Fix290 Report

Analysis of the Issues Concerning the TxDOT Hwy 290/71 Interchange Project

Prepared for Fix290.org

October 18, 2006

Screen shot captured from TxDOT's animated movie of the proposed Hwy 290/71 Interchange Project, May 2006. Labels and Williamson Creek have been added.

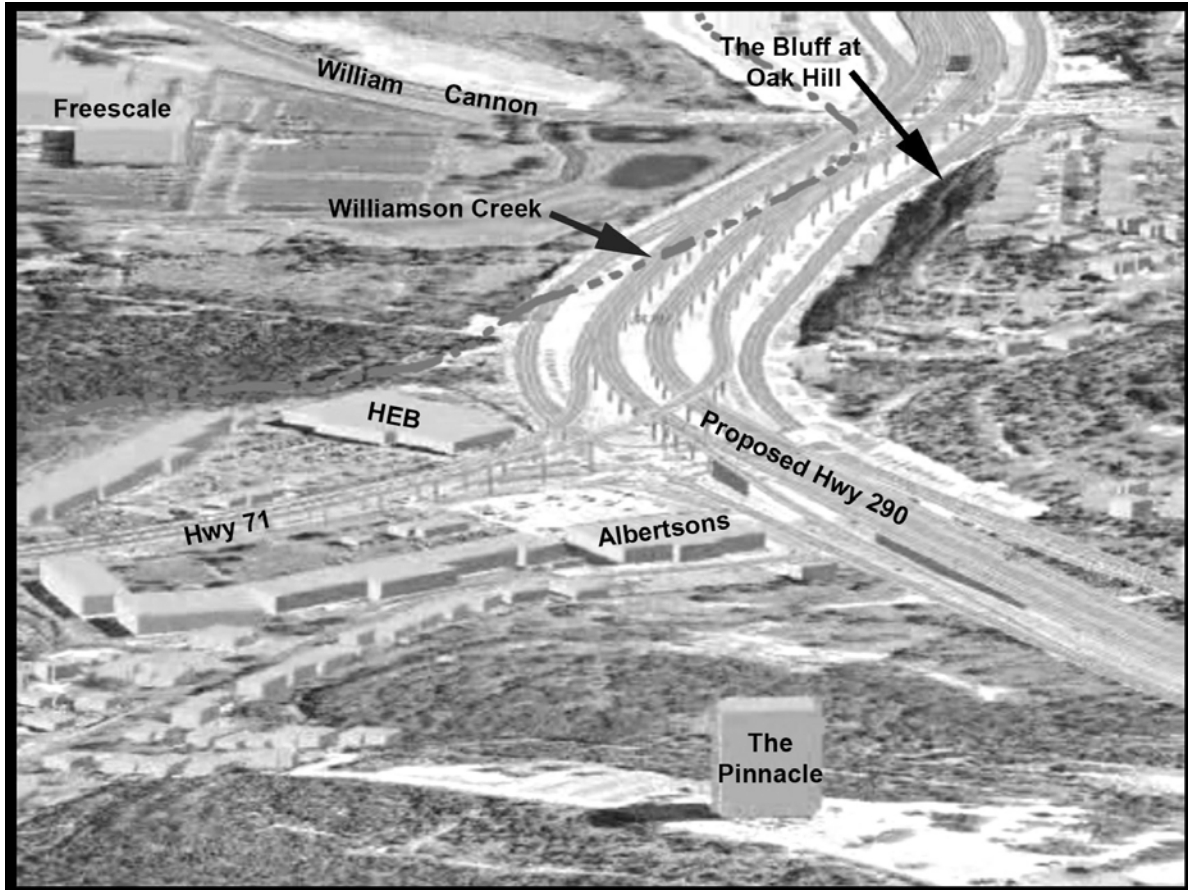
This project completely dominates the area. The project is larger than the largest natural feature in the area, the bluff at Oak Hill. The Austin Community College 10 – story Pinnacle Campus, Albertson's and HEB shopping centers will no longer be dominant in Oak Hill. The proposed TxDOT project will not be in harmony with this small community, it will be the dominant feature.

The following compares the impacts to Williamson Creek from TxDOT's and Fix290's plans.

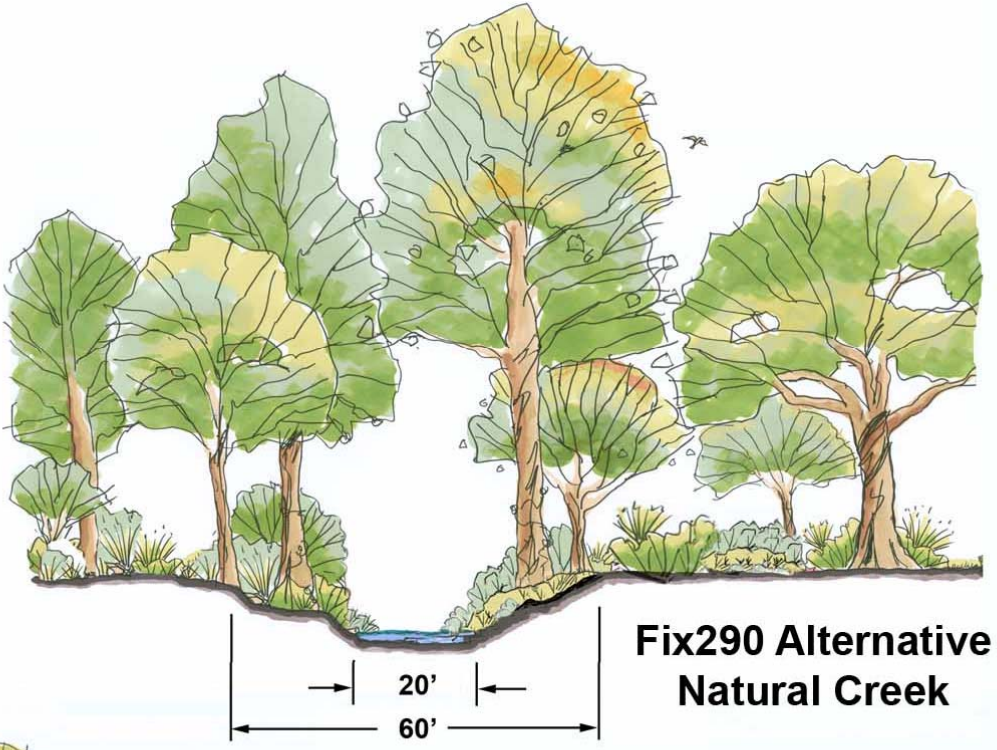
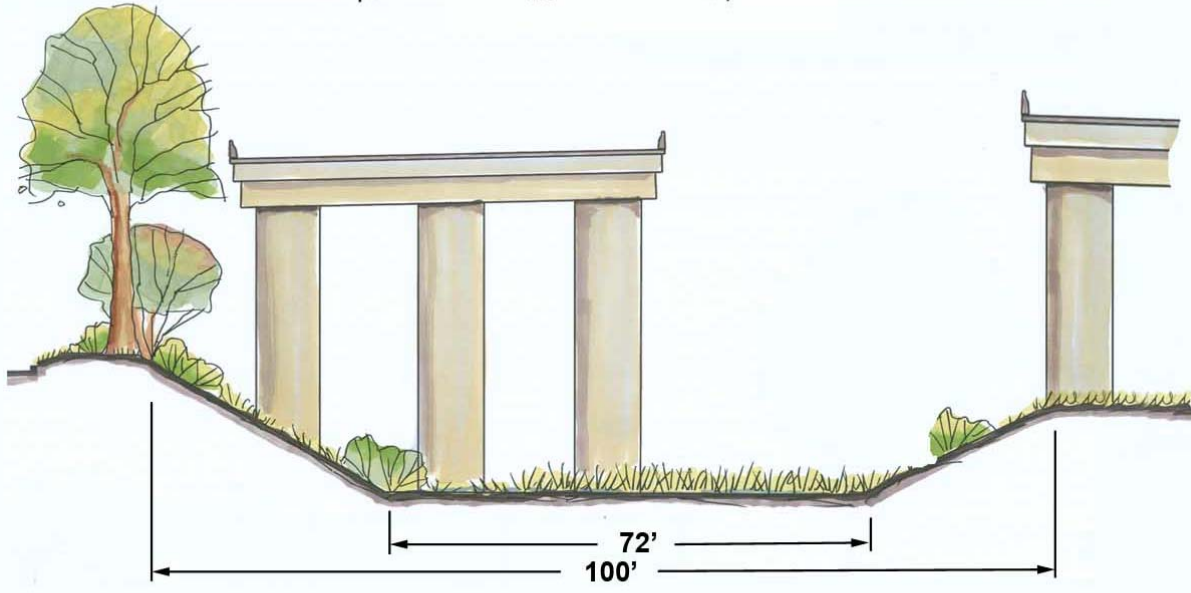
TxDOT Proposes to Remove Over a Mile of Williamson Creek

TxDOT's proposed 2006 Corps of Engineers Mitigation Plan for the Hwy 290/71 Interchange Project describes the removal of 4 acres of Williamson Creek extending over a mile downstream from the Old Bee Caves Road low water crossing to nearly the end of the Oak Hill ball fields. The average bottom width of Williamson Creek in this area is 15 to 25 feet. The TxDOT proposed creek channelization average bottom width is approximately 72 feet and the average top width near 100 feet.

The Fix290 Alternative Needs No Creek Removal for Flood Prevention

Fix290 alternative will not alter the natural development of the creek. The creek can be saved because the Fix290 concept increases the existing impervious cover in the

The Extent of the Creek Channelization

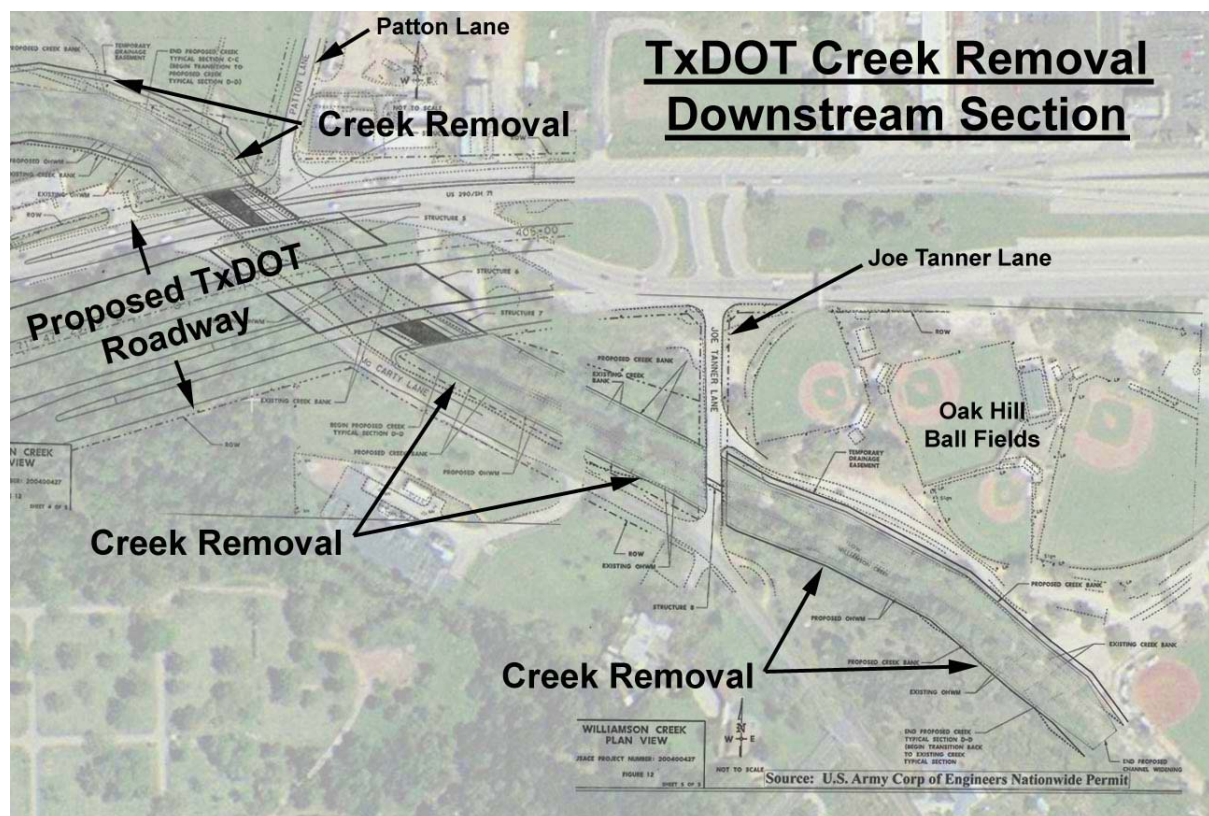
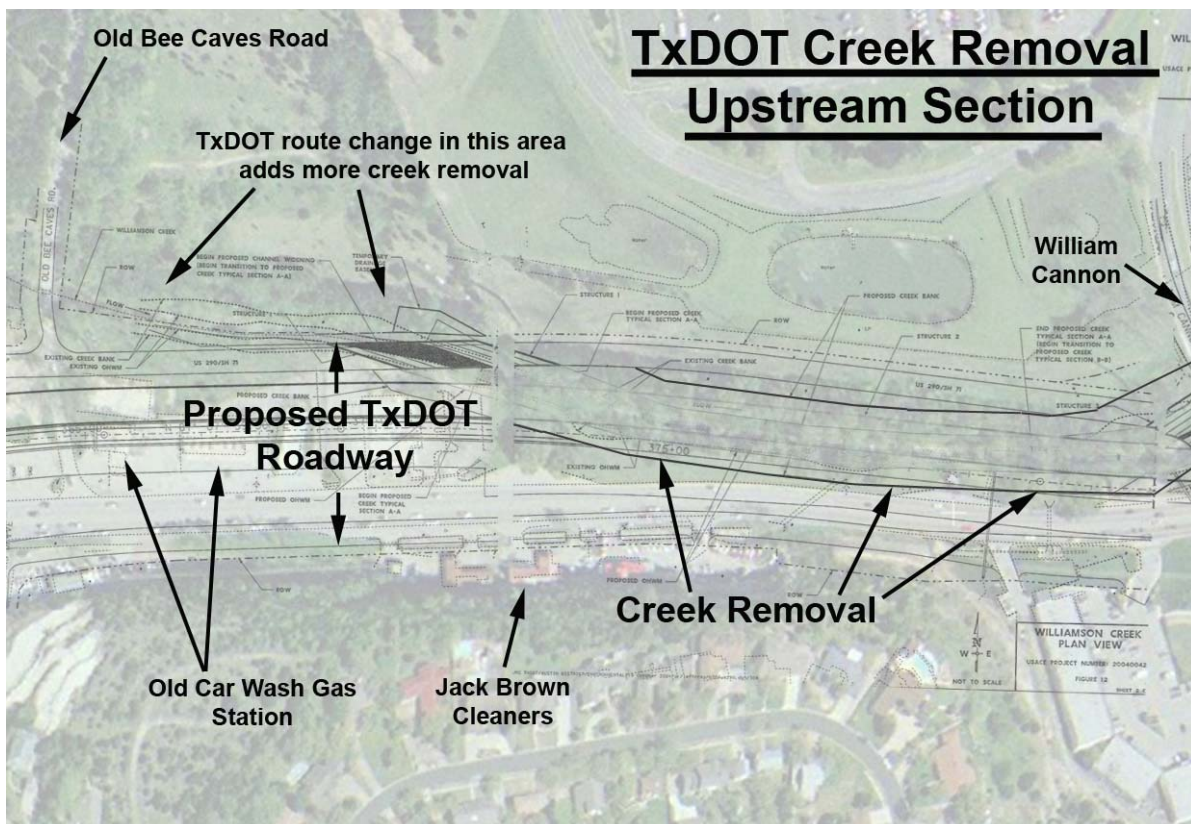
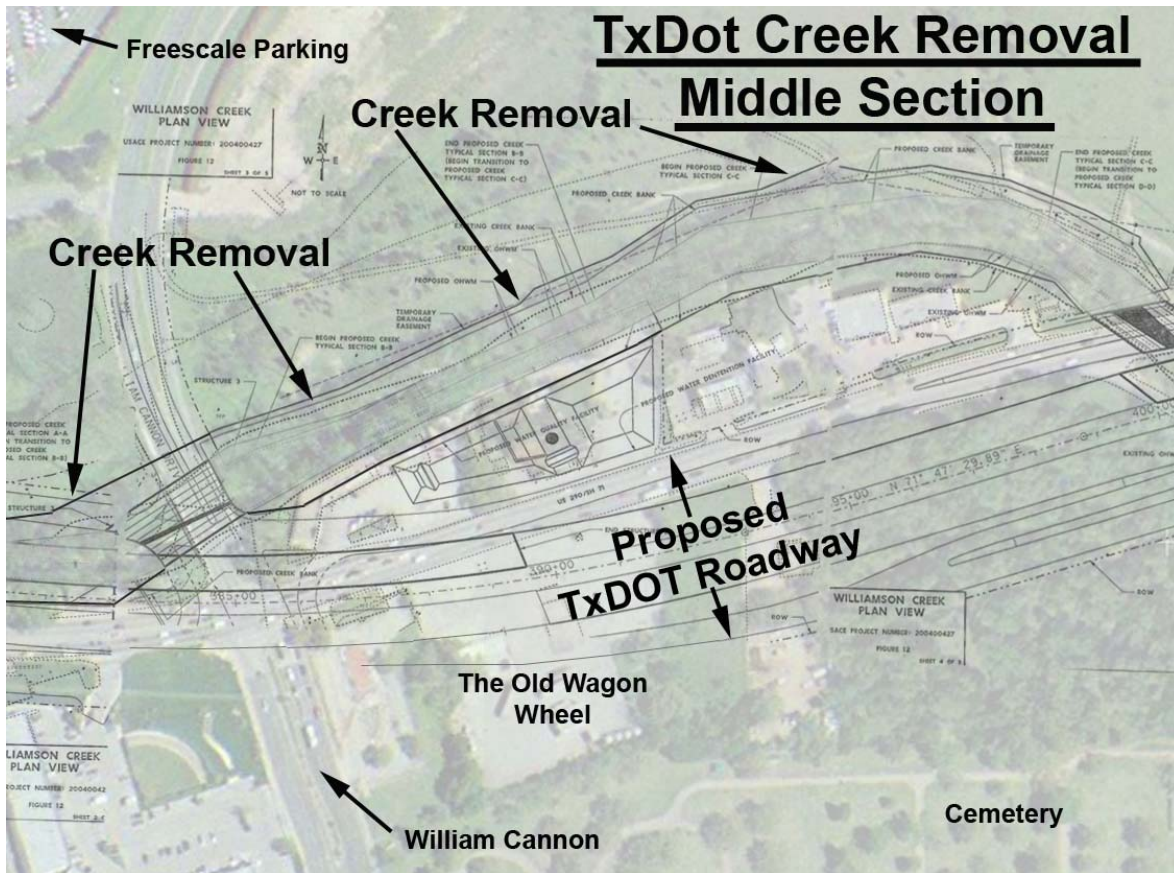
The following three images show that nearly every square foot of creek environment is entirely removed from the project area. This is an extensively wooded riparian (waterway) ecosystem with a wide diversity of plants and animals – more diversity than anything else within several miles. The environment along the creek (upstream from Hwy 290) is a classic example of a spring fed Hill Country stream. Of critical concern is the fact that downstream of the Hwy290 crossing, where the creek is usually dry, lies the Mount Bonnel Fault and the Edwards Aquifer Recharge Zone. 1,800 feet of the creek, within the limits of the recharge zone, is proposed for “improvements” consisting of a 90-foot wide channel with rock gabion (rock and chain link fence).

TxDOT's plan calls for nearly quadrupling the bottom width area of the existing creek. Almost 4,000 feet of the proposed mile of creek to be removed is a perennially spring fed creek, complete with dozens of species of aquatic plants, fish, turtles, etc. The water that is present normally in the 15 to 25 foot wide creek, when spread out over 60 to 90 feet of TxDOT's proposed flat bottom channel, will simply disappear, taking all of the aquatic life with it. This is the only spring-fed creek in Oak Hill.

A) TxDOT's Level of Service Is Worse than Fix290's

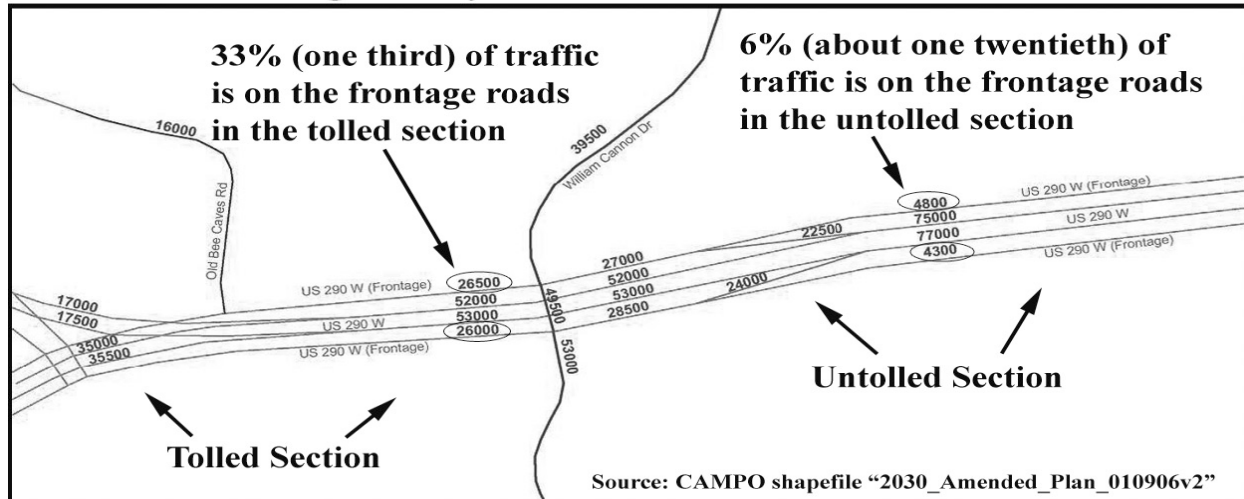
TxDOT asserts that their design offers superior performance to Fix290's, based on Smart Mobility Inc.'s (SMI) analysis that the Fix290 project will have a Level of Service (LOS) of D/E.¹ TxDOT designs their main lanes for LOS "C". TxDOT unfairly compares its proposal with Fix290's because TxDOT only uses two thirds of the total CAMPO 2030 traffic volume to get their LOS C. The rest of the traffic is shown by CAMPO 2030 to be on the frontage roads, or the "free lanes."

G) Flooding of the Main Lanes

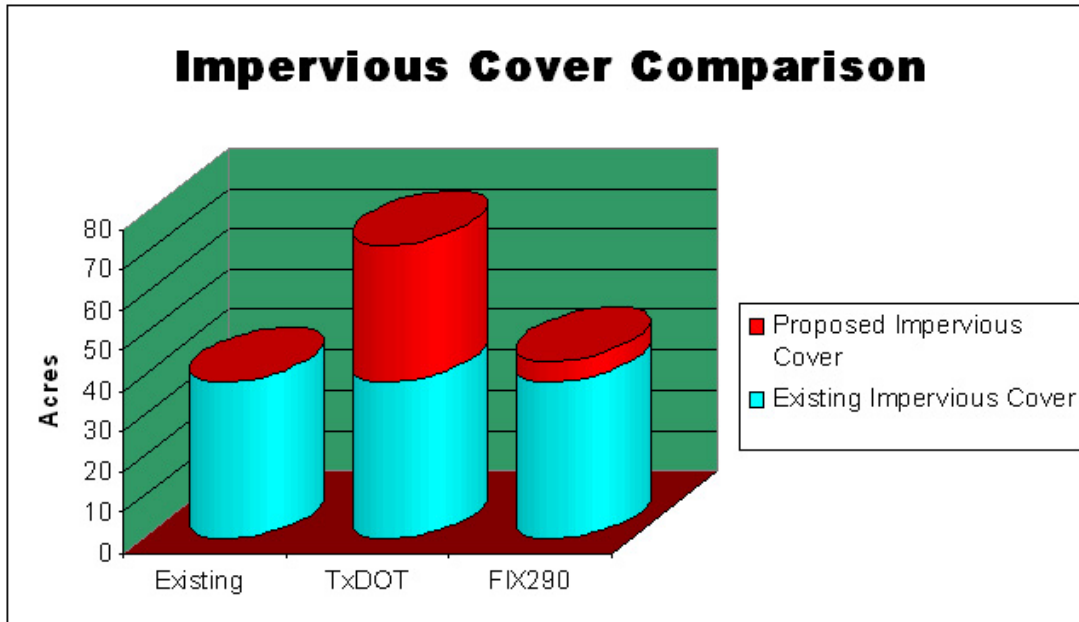
A TxDOT precedent exists to raise all main travel lanes above the height of the 25-year storm with new construction. There are a number of techniques and assumptions that will allow the Fix290 concept to have only minimal, if any, impacts on Williamson Creek, and still meet TxDOT flood precedent.

- And of course, excavation methods and roadway elevation methods can be used to remove the roadway from the 25-year flood. The roadway will have to be raised a few to several feet. These changes can be made without any creek channelization.
